LAND SOUTH OF THE A271 AND
EAST OF THE A22, LOWER
HORSEBRIDGE, HAILSHAM

**Correspondence from WDC Landscape
Witness Requesting Visualisations**

Landscape Briefing Note – 01

Date: 29th February 2024
Purpose: Request for Visualisations
Reference: 1285 BN01 Visualisations

MB SKETCH 1A
Proposed Visualisation Locations

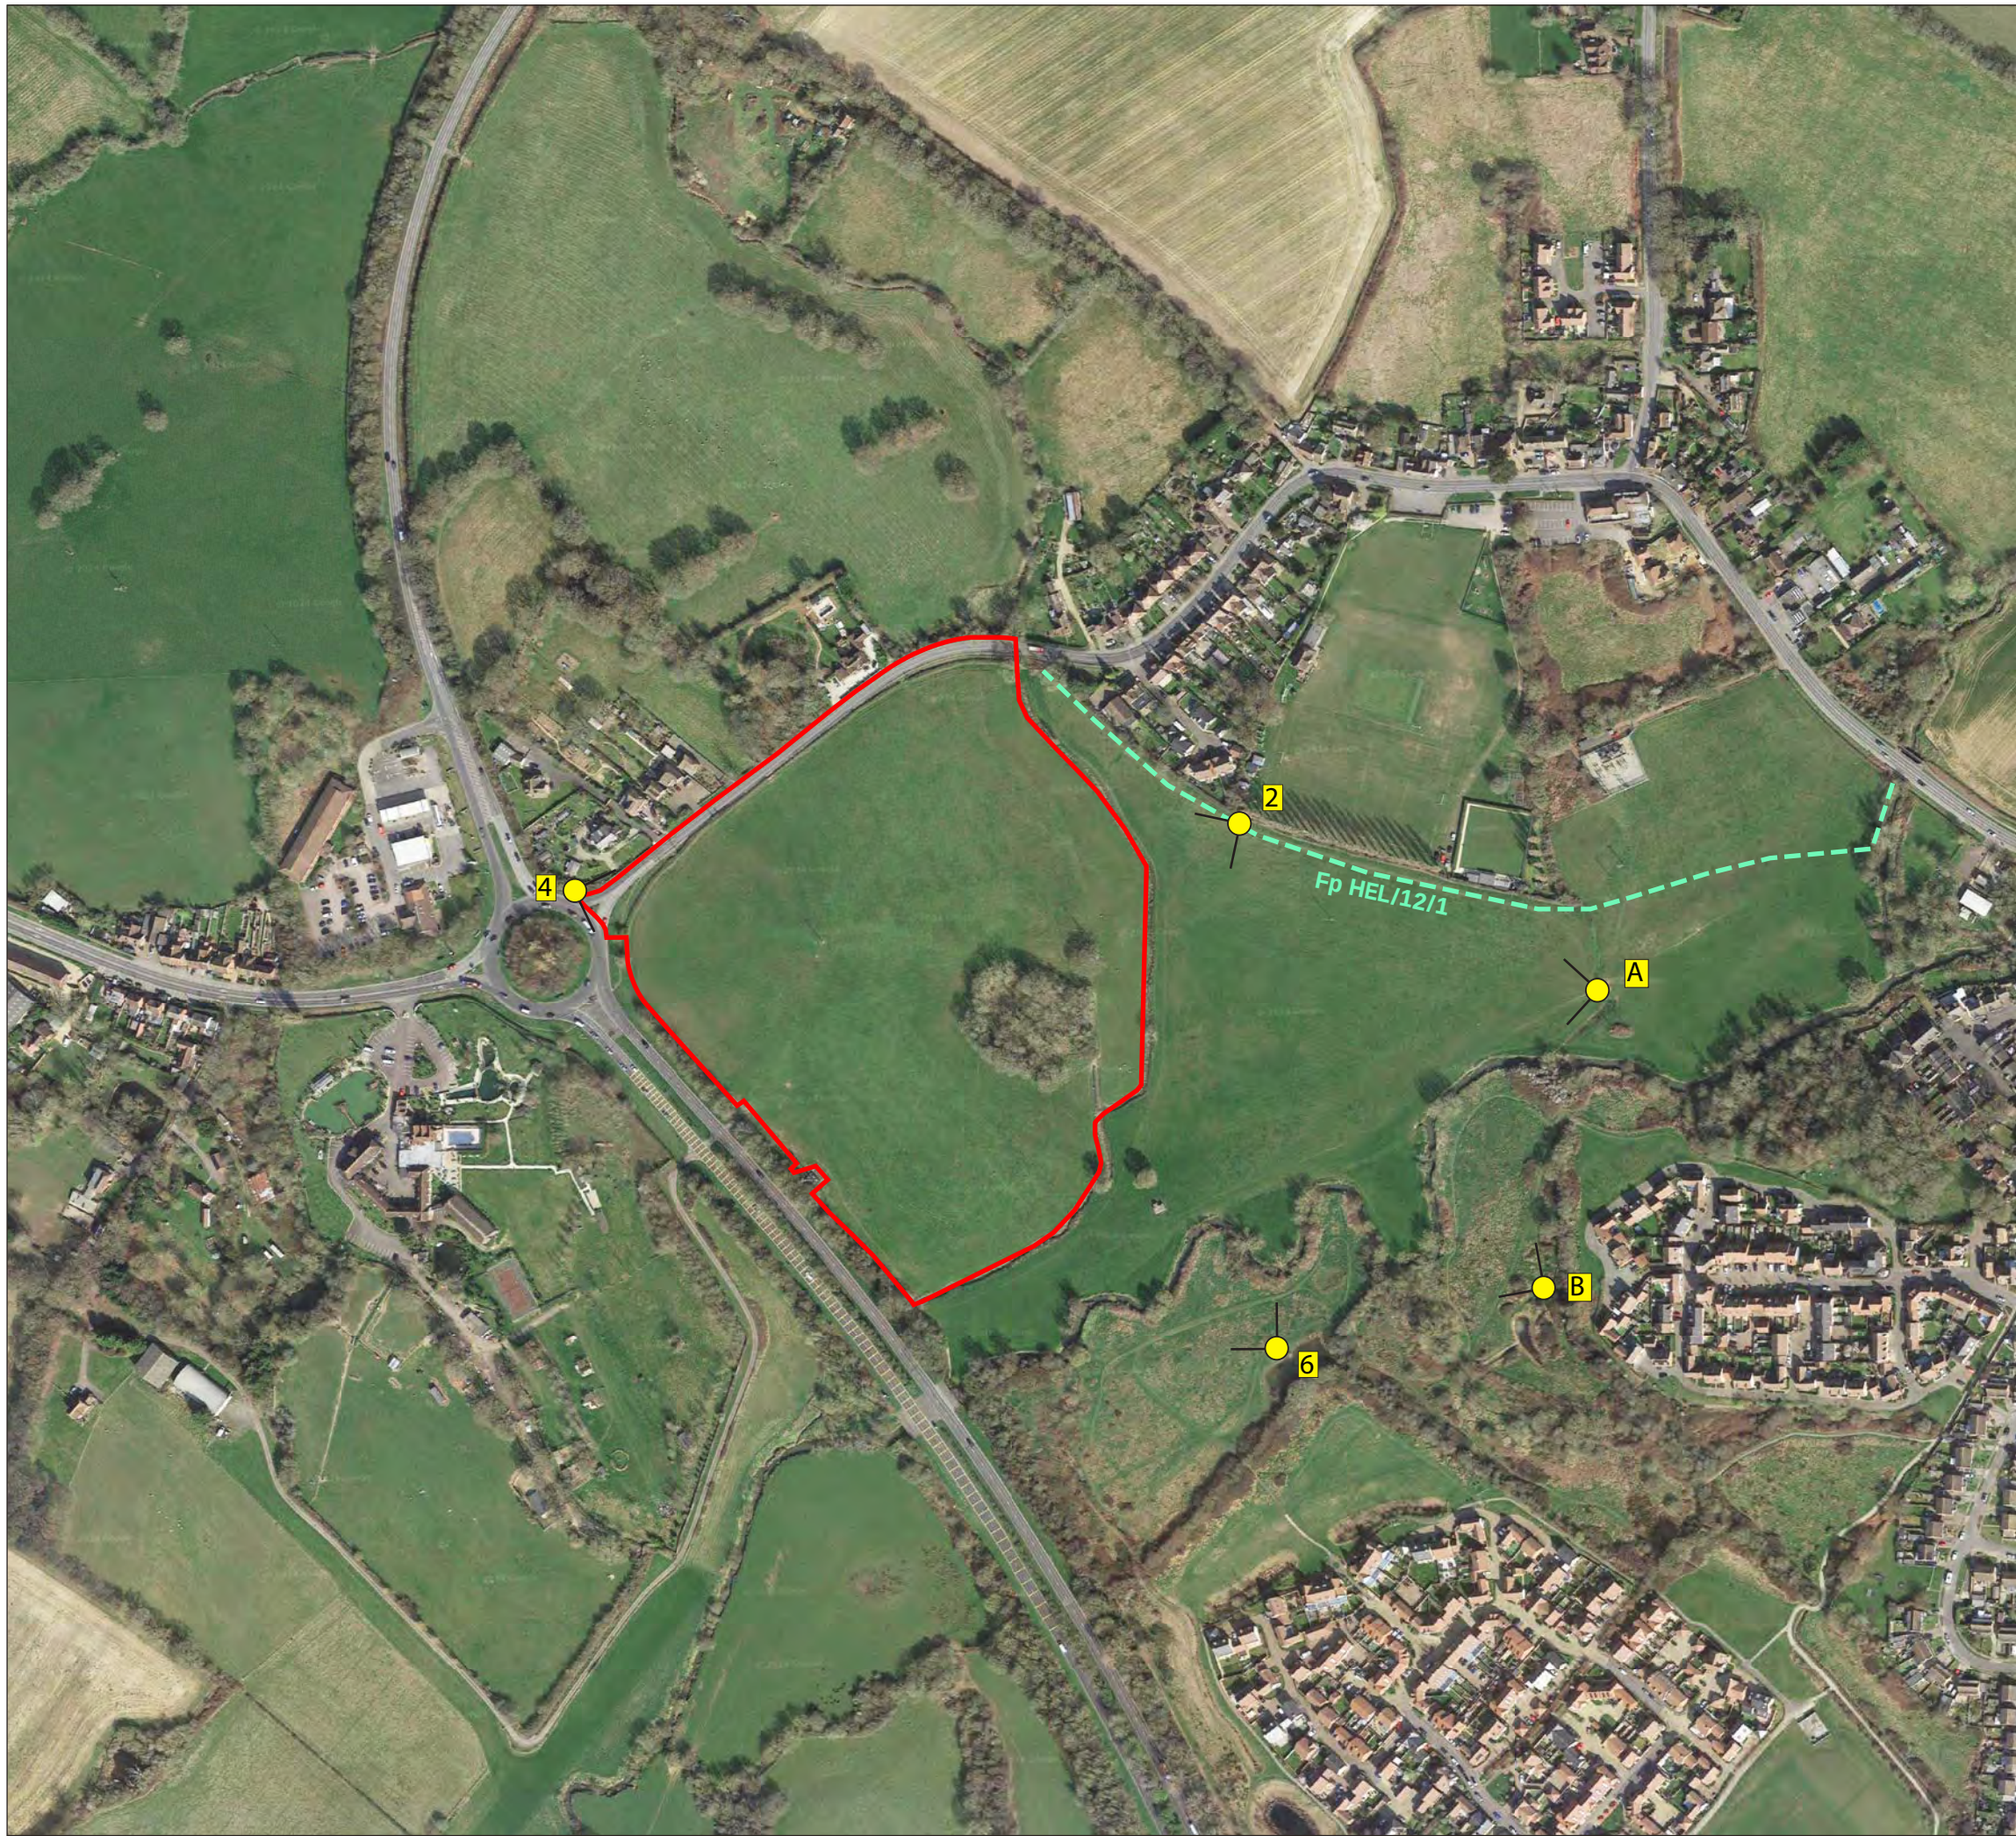
4. To illustrate the visual effect of the proposals, I consider verified views from the following locations should be prepared:

- LVA Vp 2 from Fp HEL/12/1;
 - LVA Vp 4 looking across the roundabout;
 - LVA Vp 6 from open space at Welbury Meadow.

- Viewpoint A - from before the earth bridge used to cross the ditch when on Fp HEL/12/1
 - Viewpoint B - from the public open space on the edge of Halisham.

-
5. Viewpoint 4 should include the proposed road widening measures and the design measures, with regard to the buildings, that might be employed to achieve the required noise levels within the site.
 6. Viewpoint B has also been requested with regard to the heritage assessment.
 7. It would be preferable if the verified views were Type 4 visualisations and showed the following:
 - The proposals at completion;
 - The proposals at year 15 of operation;
 8. In line with TGN 06/19 Each visualisation should be presented as a separate panoramic view and a single frame view (40' horizontal field of view), both at A3 paper size. The single frame should be chosen to include the key part of the image.
 - A viewpoint location plan based on an OS map that includes the proposals; and
 - Methodology explaining the process of visualisation preparation.
